ADDENDUM NO. 3

February 6, 2023

**SOLON ROBINSON ELEMENTARY SCHOOL ADDITIONS,
RENOVATIONS, AND RELATED WORK
Crown Point, IN 46307**

**UNIT "D" FIRST FLOOR
EQUIPMENT PLAN**

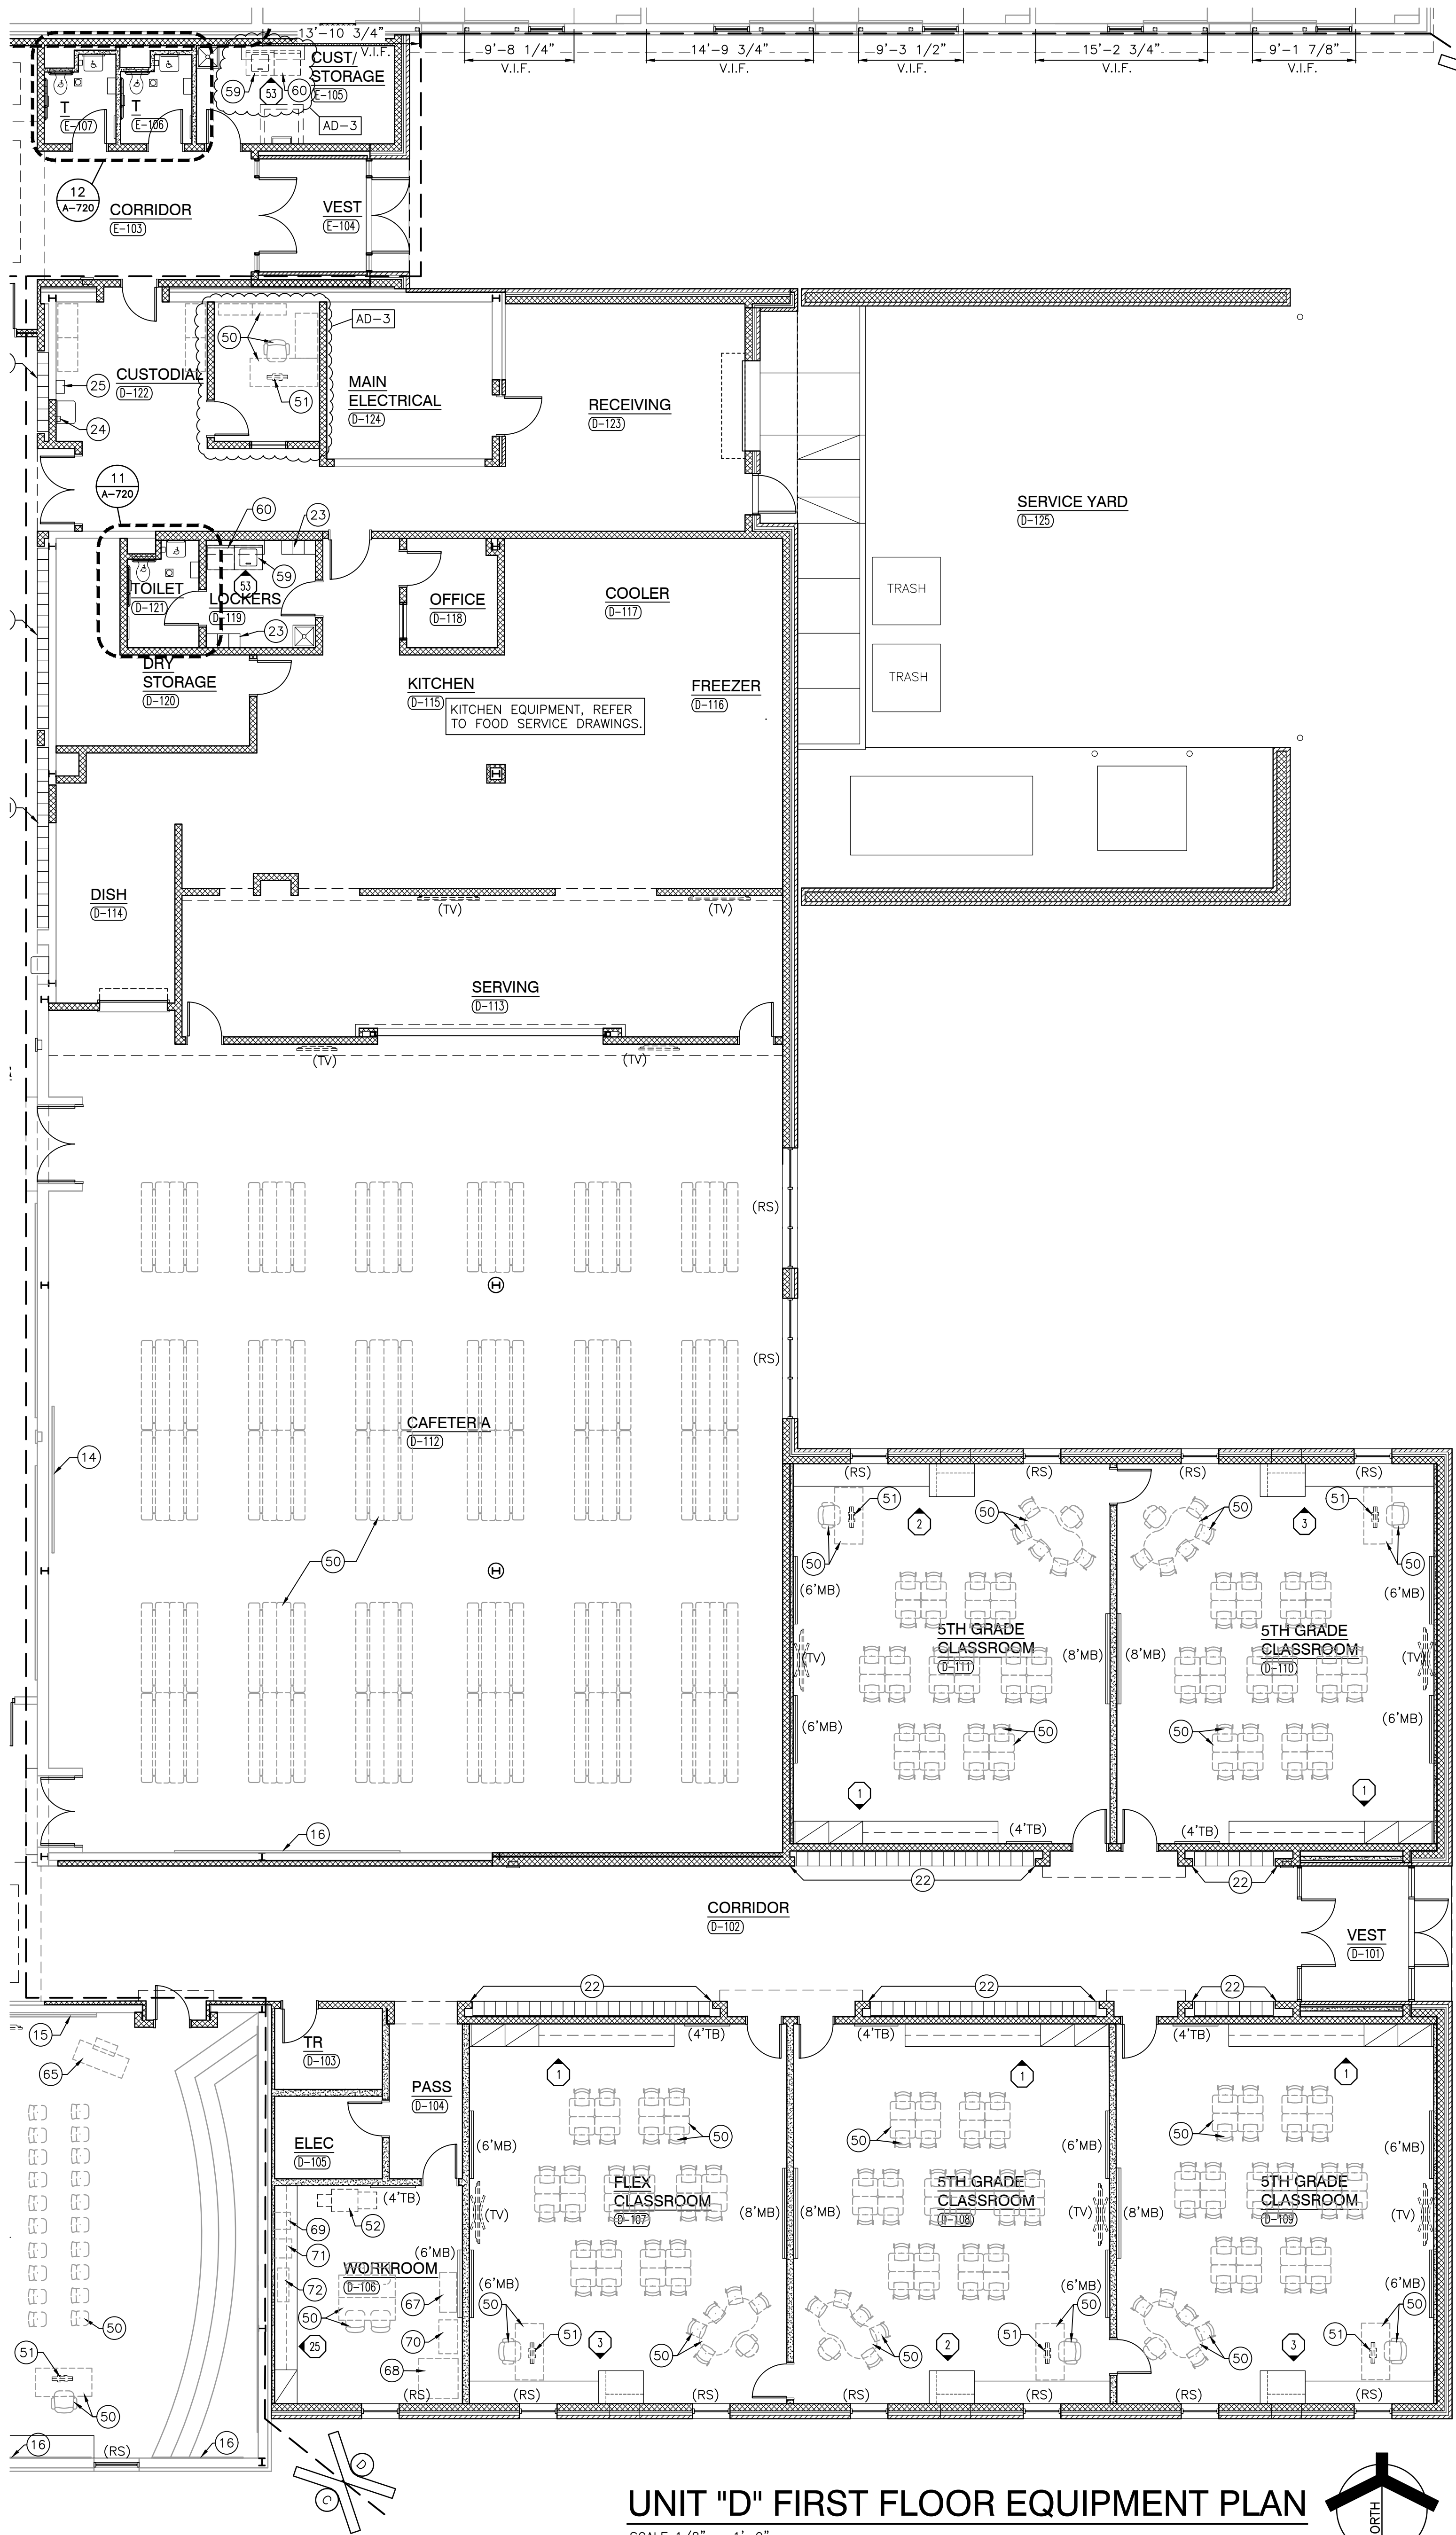
- A. Unit "D" First Floor Equipment Plan: Move washer and dryer from Custodial D-122 to Cust/Storage E-106 and add equipment in new Custodial Office D-126.

FIRE PROTECTION ZONING PLAN / FIRE INSPECTORS TEST CONNECTION

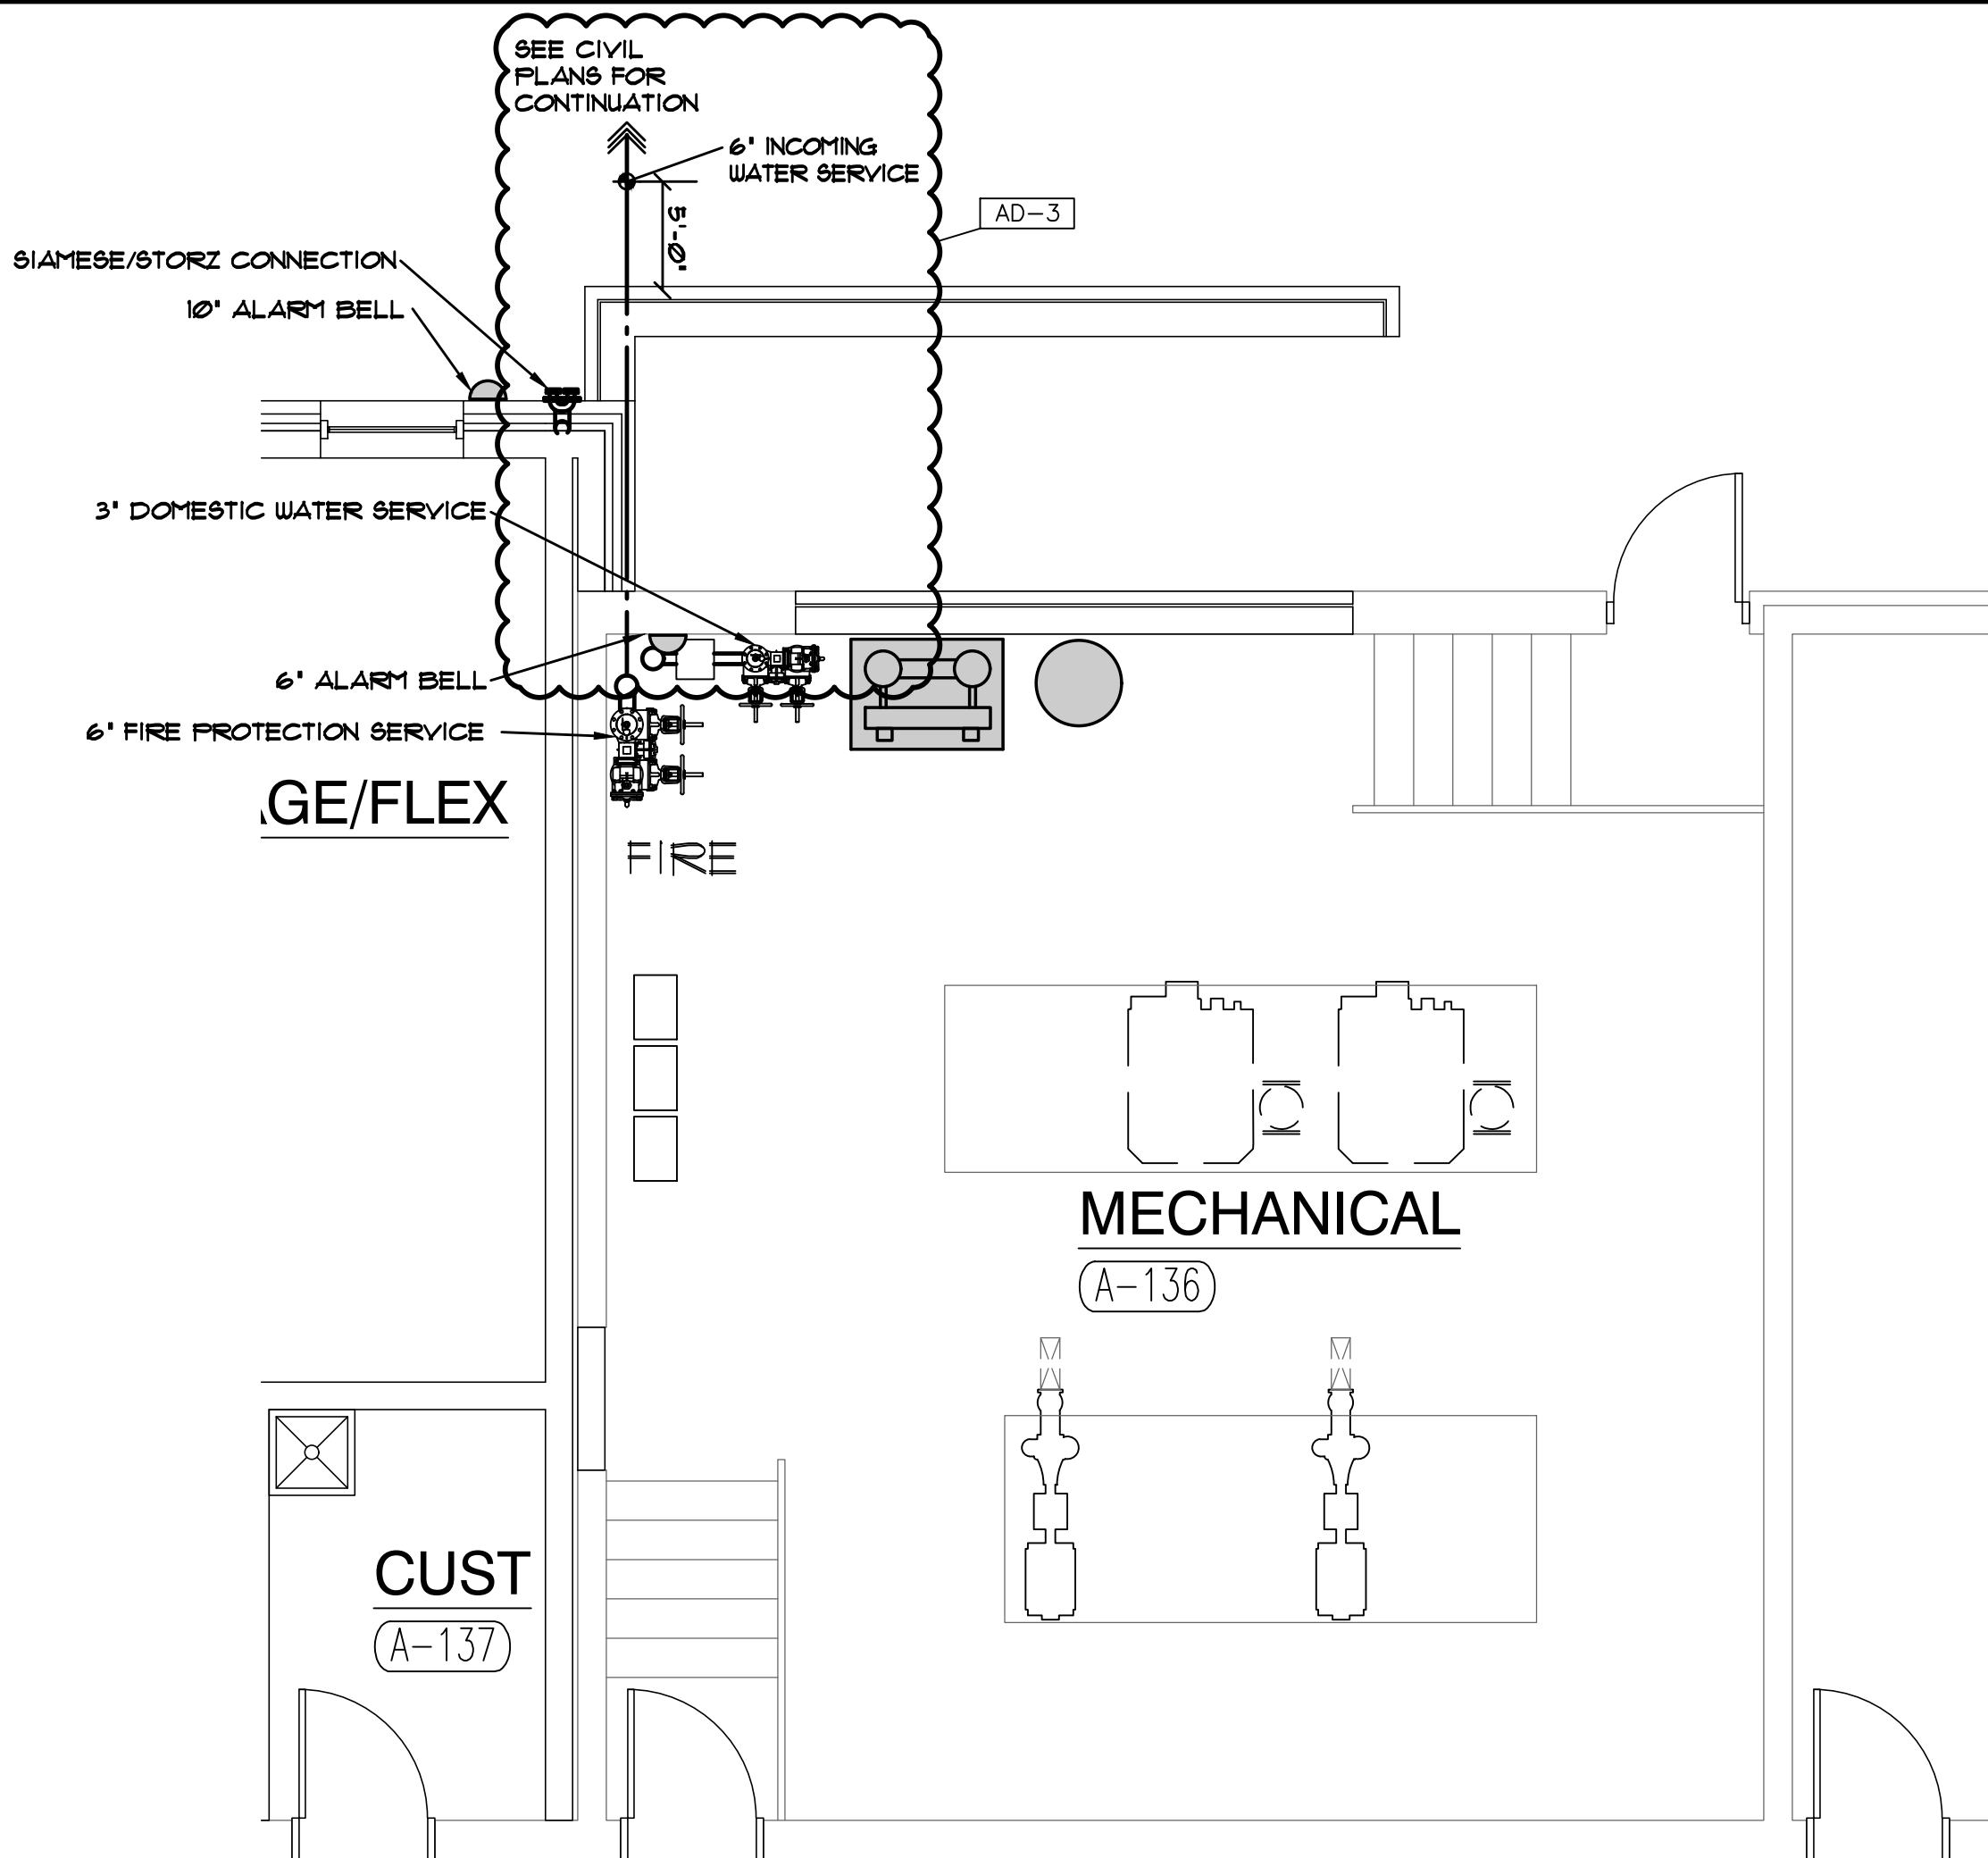
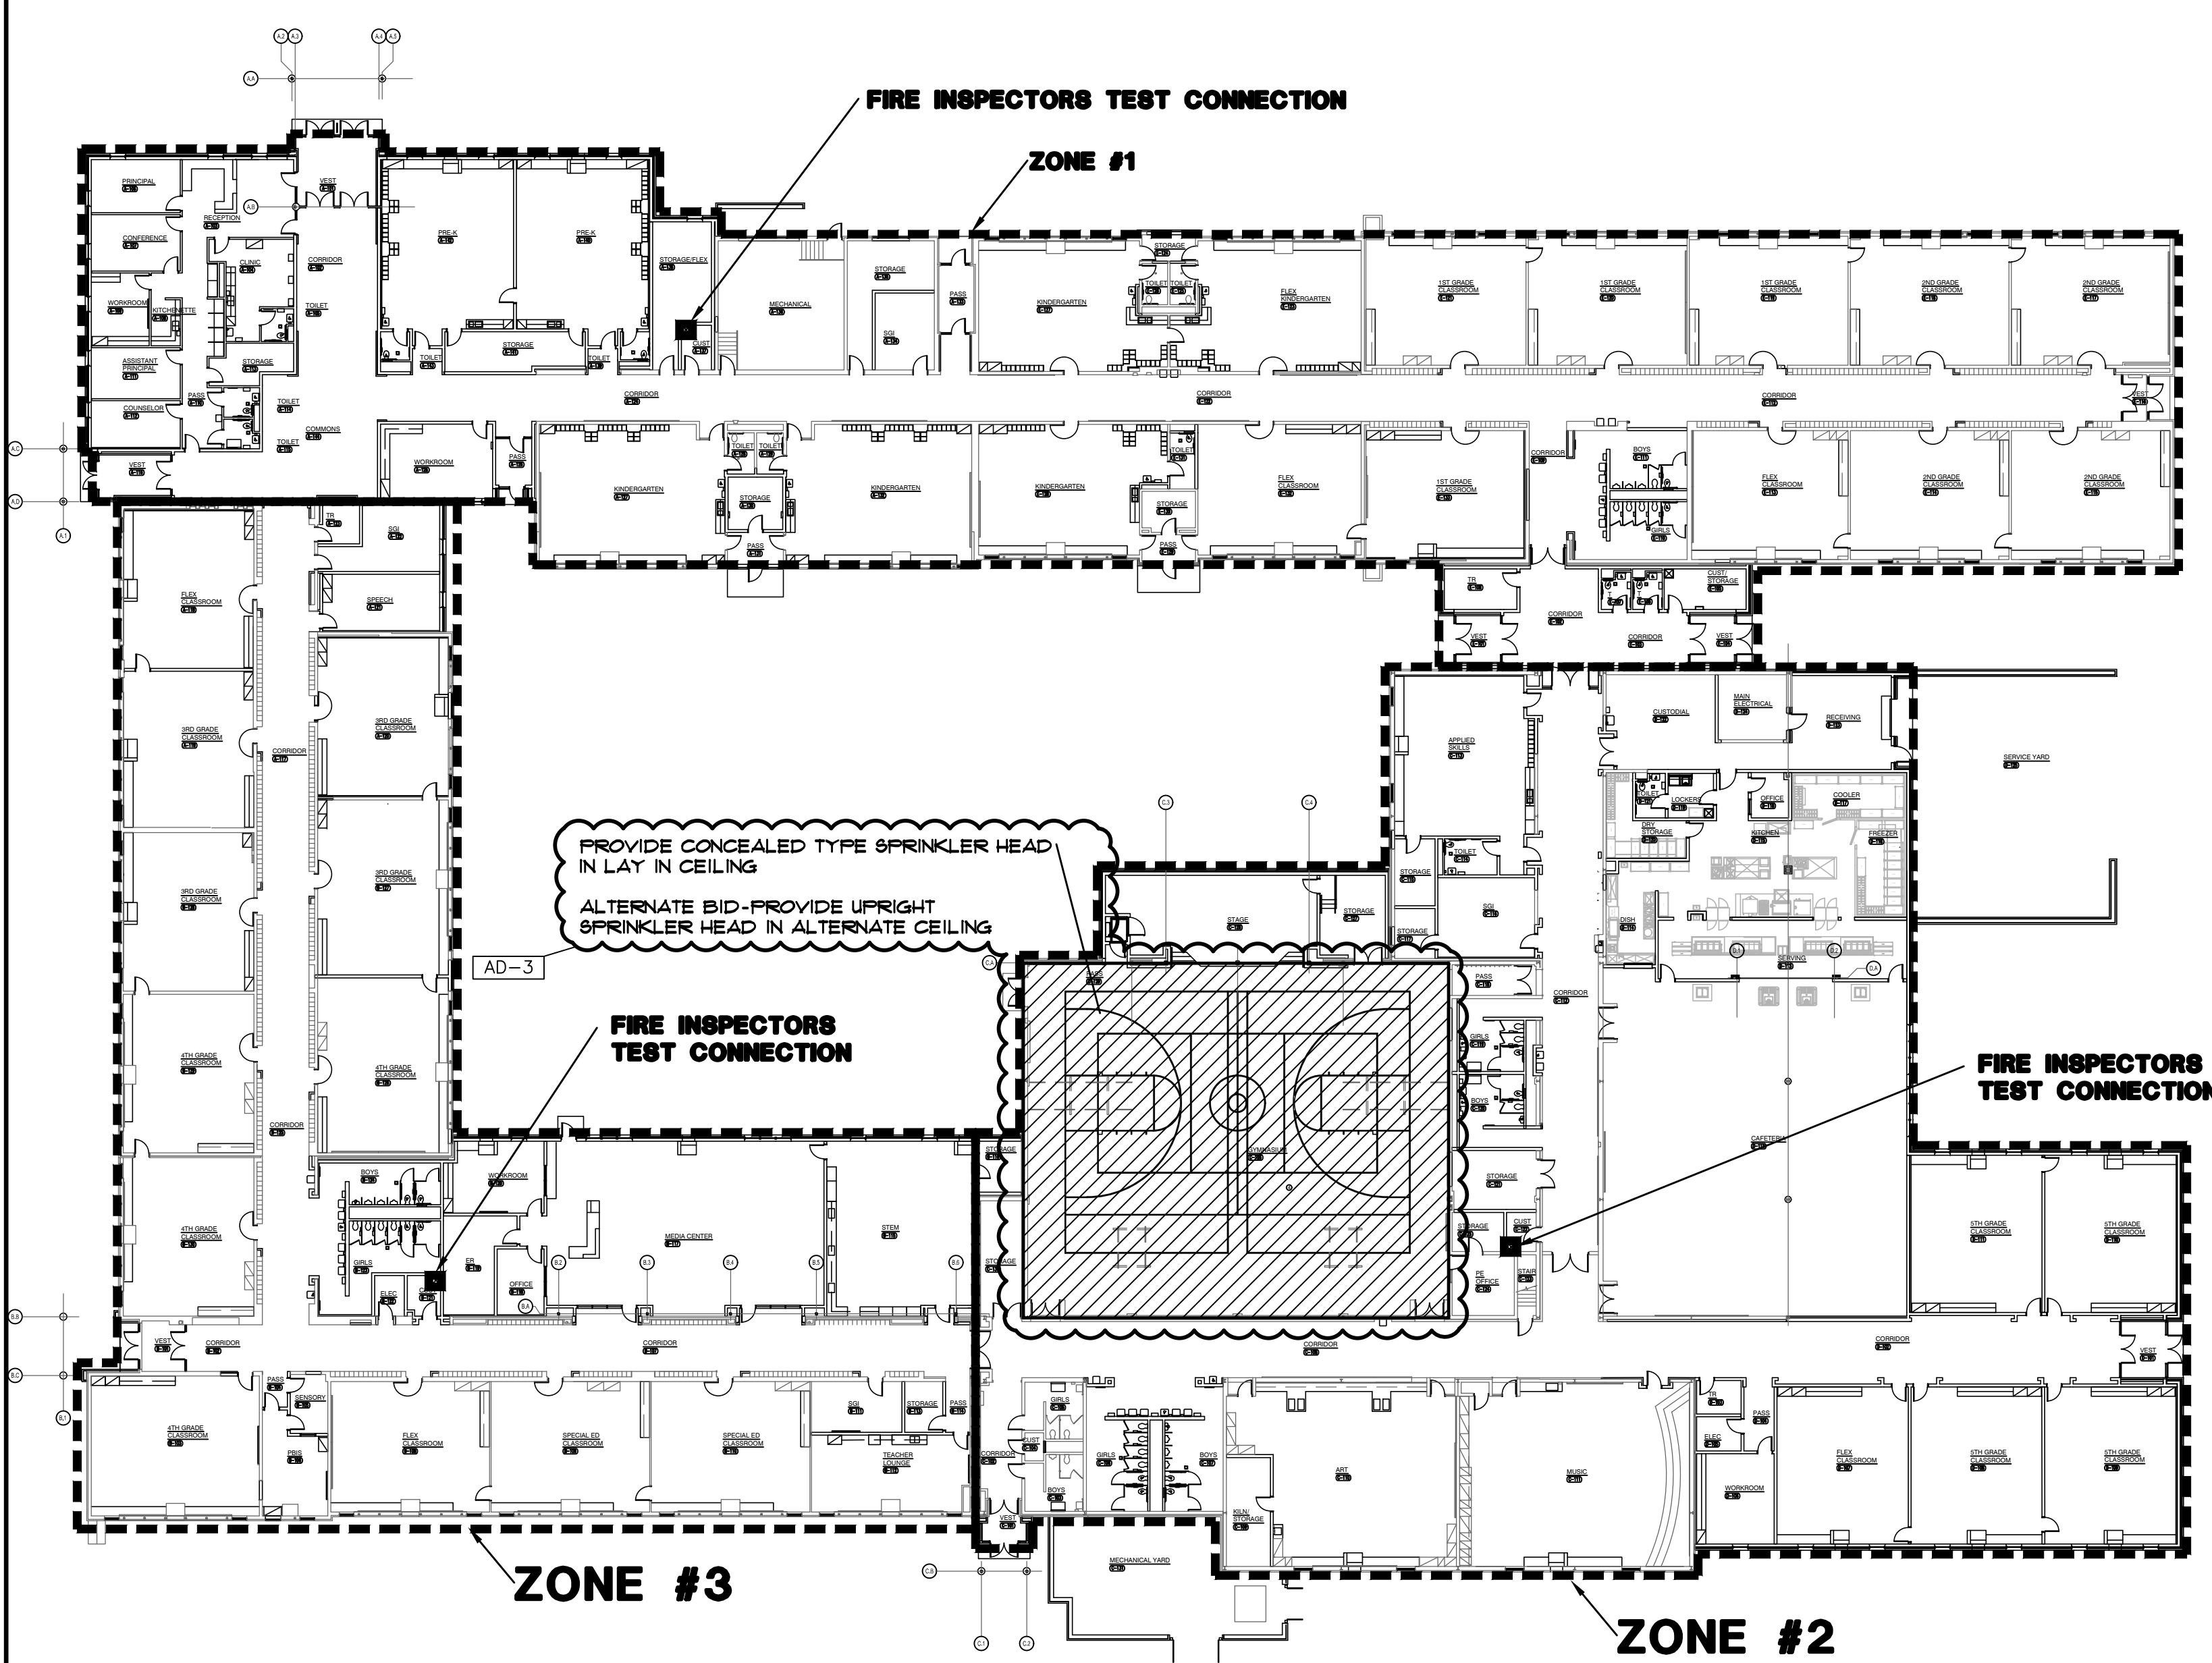
- A. Revise for new 6: incoming fire service.
